# UNITED STATES PATENT AND TRADEMARK OFFICE

APPLICATION NO.	FILING DATE	FIRST NAMED INVENTOR	ATTORNEY DOCKET NO.	CONFIRMATION NO.
10/510,351	10/06/2004	Ernest R. Bodnar	1120U106	9530

<b>Office Action Summary</b>	<b>Application No.</b>	<b>Applicant(s)</b>	
	10/510,351	BODNAR, ERNEST R.	
	<b>Examiner</b>	<b>Art Unit</b>	
	CHRISTINE T. CAJILIG	3633

Title : STEEL STUD WITH OPENINGS AND EDGE FORMATIONS  
AND METHOD

*Annotated Figures*

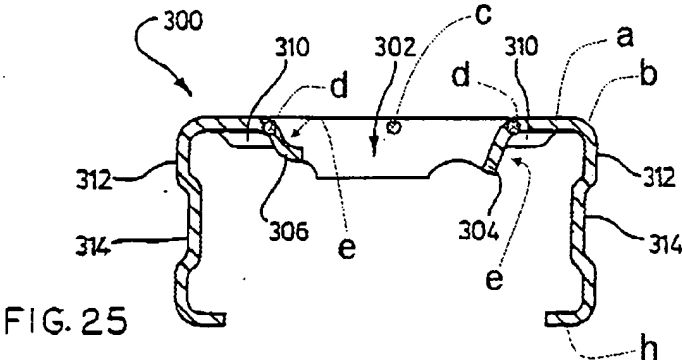
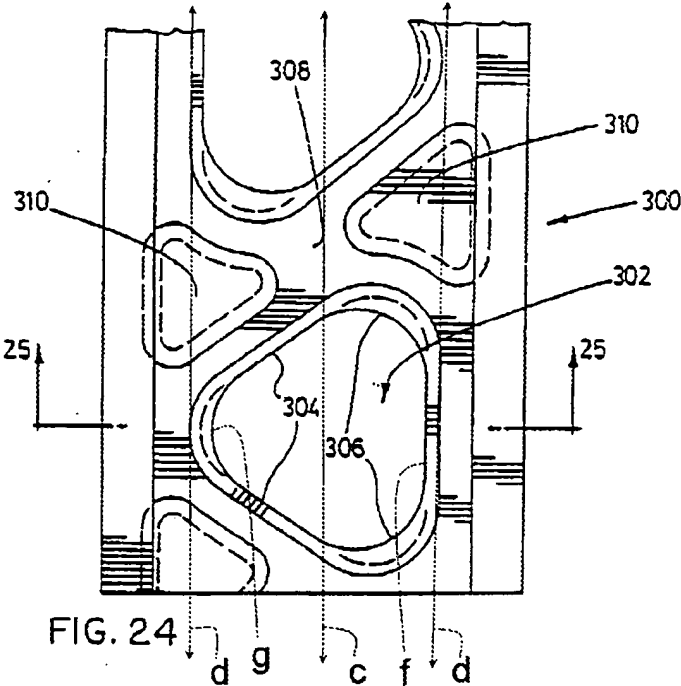
Regarding claim 1, Rafter '384 in Figure 1 discloses a metal member for use in supporting structures and having reduced heat transfer characteristics as compared with solid web studs, and characterized by a web (1) defining side edges and an axis (a); a flange (5) on at least one side edge; openings (2) through said web at spaced intervals therealong, of predetermined size and profile, at least a side portion (3, 4) of said web being removed from said opening and remaining attached integrally to said web, and being bent away from said web along axes (b) parallel to said web axis (a), but does not disclose that the member is steel. However, it would have been obvious to one having ordinary skill in the art at the time of invention to use steel, since it has been held to be within the general skill of a worker in the art to select a known material on the basis of its suitability for the intended use as a matter of obvious design choice. *In re Leshin*, 227 F.2d 197, 125 USPQ 416 (CCPA 1960)

Regarding claim 3, Rafter '384 discloses the structure discussed above and further discloses that said side portion (3, 4) defines a channel shape (created by 3 and 4) extending along an axis (between axes a and b) parallel to said web axis.

Bodnar '625

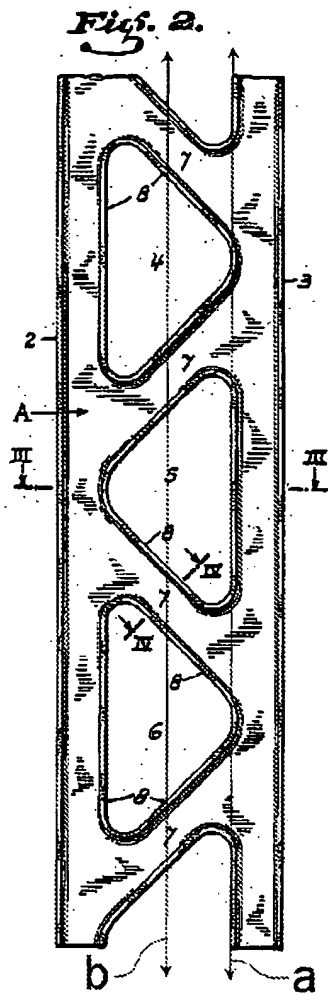
Regarding claim 1, Bodnar '625 in Figures 24-25 discloses a steel member for use in supporting structures and having reduced heat transfer characteristics as compared with solid web studs, and characterized by a web (a) defining side edges and an axis (c); a flange (312) on at least one side edge; openings (302) through said web at spaced intervals therealong, of predetermined size and profile, at least a side portion (304, 306) of said web being removed from said opening and remaining attached integrally to said web, and being bent away from said web along axes (d) parallel to said web axis (c).

Regarding claim 3, Bodnar '625 discloses the structure discussed above and further discloses that said side portion (304, 306) defines a channel shape (e) extending along an axis parallel to said web axis.

Regarding claim 4, Bodnar '625 discloses the structure discussed above and further discloses that said openings (302) are of a shape defining a linear side edge (f), and an arcuate side edge (g), said side portion (304, 306) of said web being integral with said linear side edge (f).

Regarding claim 5, Bodnar '625 discloses the structure discussed above and further discloses that there are two said flanges (312) one on each side of said web, being formed at normal to said web, and lips (h) formed along said flanges and normal to said flanges.

Regarding claim 6, Bodnar '625 discloses the structure discussed above and further discloses that openings (302) are arranged in an alternating orientation and struts (308) are defined between said openings, said struts extending diagonally across said member.

Regarding claim 26, Bodnar '625 in Figures 24-25 discloses a steel member having a web (a), side edges, and a flange (312) along at least one said side edge and openings (302) through said web wherein said openings (302) are formed in said web at spaced intervals therealong, with one of said openings leaving a side portion of metal attached to said web forming an edge flange (304, 306) along said at least one side edge of said web and forming said side portion out of the plane of said web wherein said side portion is bent along bend lines (d) parallel to the web axis (c). Therefore, the method steps set forth in claim 26 of forming the steel member with the above said structure and bending side portions would have been an obvious if not inherent method of making the steel member having the same structure.

Folsom '781

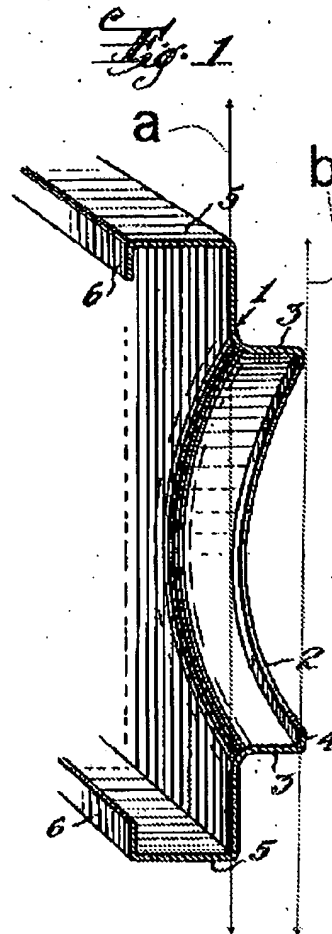
Regarding claim 1, Folsom '781 in Figures 1 and 2 discloses a metal member for use in supporting structures and having reduced heat transfer characteristics as

compared with solid web studs, and characterized by a web (A) defining side edges and an axis (b); a flange (3) on at least one side edge; openings (4-6) through said web at spaced intervals therealong, of predetermined size and profile, at least a side portion (8) of said web being removed from said opening and remaining attached integrally to said web, and being bent away from said web along axes (a) parallel to said web axis (b), but does not disclose that the member is steel. However, it would have been obvious to one having ordinary skill in the art at the time of invention to use steel, since it has been held to be within the general skill of a worker in the art to select a known material on the basis of its suitability for the intended use as a matter of obvious design choice. *In re Leshin*, 227 F.2d 197, 125 USPQ 416 (CCPA 1960)

Regarding claim 6, Folsom '781 discloses the structure discussed above and further discloses that said openings (406) are arranged in an alternating orientation and struts (7) are defined between said openings, said struts extending diagonally across said member.

Regarding claim 26, Folsom '781 discloses a steel member having a web (A), side edges, and a flange (3) along at least one said side edge and openings (4-6) through said web wherein said openings (4-6) are formed in said web at spaced intervals therealong, with one of said openings leaving a side portion of metal attached to said web forming an edge flange (8) along said at least one side edge of said web and forming said side portion out of the plane of said web wherein said side portion is bent along bend lines (a) parallel to the web axis (b). Therefore, the method steps set forth in claim 26 of forming the steel member with the above said structure and bending
